STAFF REPORT MARCH 12, 2025, REGULAR MEETING

APPLICATION NUMBER: HDC2024-00706

ADDRESS: 618 ARDEN PARK

SCOPE: ERECT DWELLING AND GARAGE

Elevation drawing of proposed house, from application materials.

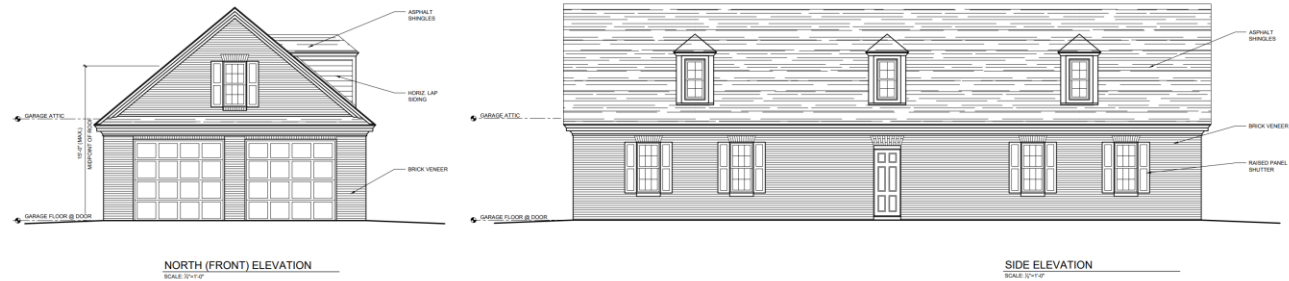
- Further, although not connected to a specific element, staff suggests that the lack of fenestration on the sides (east and west elevations) of the proposed house is a concern. The west elevation (see image on page 4 of this report) has only two, centered window openings, with large expanses of blank wall on either end. The east elevation has one door but no window openings. Staff opinion is that these large expanses of unfenestrated wall area result in an appearance and overall lack of detail and complexity that is incongruous and incompatible with the Colonial Revival style of the proposed building and is inconsistent with other buildings within the district.

- Finally, staff suggests that there is an overall lack of detail in the submitted drawings. To achieve

compatibility, details such as lintels, jack arches, doorway details, windows, and entablature should be projected or be recessed as appropriate to add a sense of texture, depth, and shadow to break up the otherwise flat, planar façade of the building.

- The bright white or pure white colors are incompatible with the Colonial Revival style of the building and with the district as a whole.
- Section drawings are not provided; the window and door openings and associated details, entablature on both the porch and eaves, and other façade details must have adequate depth and texture to avoid a flat or shallow appearance.

- The expanses of unfenestrated, blank brick wall on the sides (east and west elevations) of the house are incompatible with the Colonial Revival style of the building and with the character of the district as a whole.

- The site plan shall be adjusted to provide a ten-foot west setback, subject to staff approval.
- The trim boards, siding, and balustrade shall be wood.
- The shutters and garage door selection shall be subject to staff approval for compatibility with the Elements of Design.

- The wall material shall employ true brick with a recessed mortar joint, subject to staff approval.
- Window color and trim color shall be consistent with Color System C (Colonial Revival, Neo-Dutch Colonial, Neo-Georgian, Post-Depression Colonial), subject to staff approval.
- Section drawings of façade details shall be provided to ensure appropriate depth and complexity, subject to staff approval.
- Additional fenestration shall be added to the sides (east and west elevations) of the house, subject to staff approval.

Elevation drawing of proposed garage, from application materials.

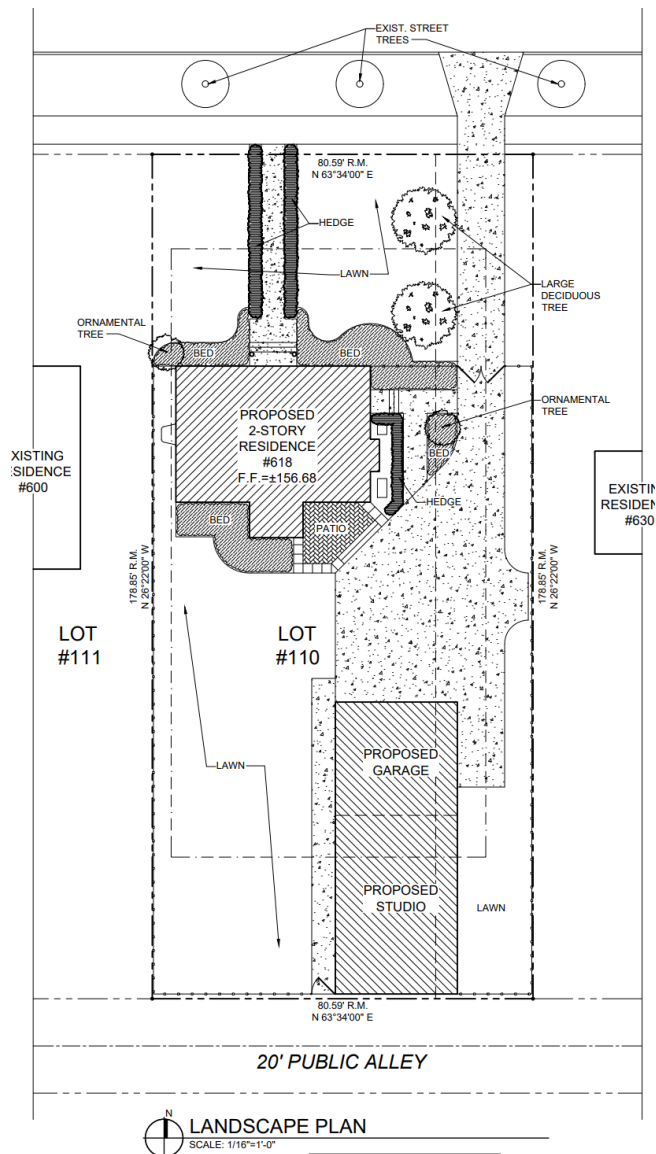
- Staff notes that the unusually deep footprint of the garage is uncharacteristic with respect to other, historic garages in the district. However, staff opinion is that this effect is mitigated by facing the narrow, two-bay face of the building towards the street, lessening the overall effect. Staff also notes that the position of the garage with respect to the house and the two deciduous trees shown on the landscape plan will render it less prominently visible.
